Basik air concept
2010 RN 97
83340 Le Luc
FRANCE

#### **SERVICE BULLETIN**

### **Document I-2**

Subject: Addendum of S.B. n° 051101 from 3/11/05

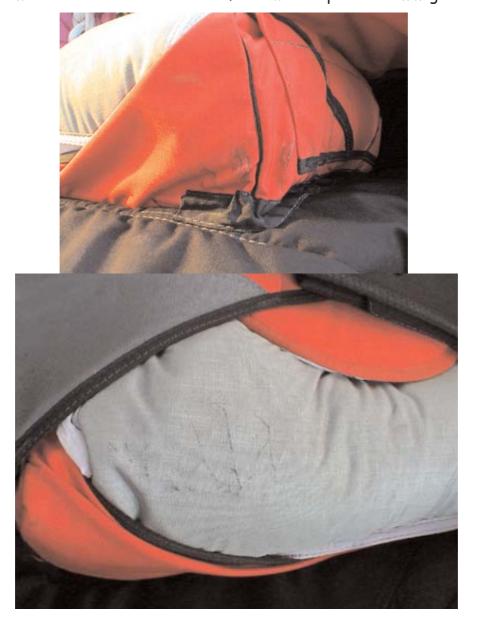
After eyesight some photos that we've recovered (we haven't still the equipment to disposal), the main pilot chute inflated on the right side and a very hard opening happened while the student was in the head down position left slice side. This hard opening has provoking the stiches failure of the chest strap and of some secondary stiches as well.

Container juction with the lateral webbing as been slightly damaged too.

Several burns done by the main canopy lines and risers are on the reserve container divider flap and on the reserve bag as well.

Stiches from the reserve container reinforcement tape are dammaged too.

Because of the important stress the reserve bag has been push downward the bottom of the reserve container. The reserve pin stayed secured. This shown how big the forces transfer has been developped.
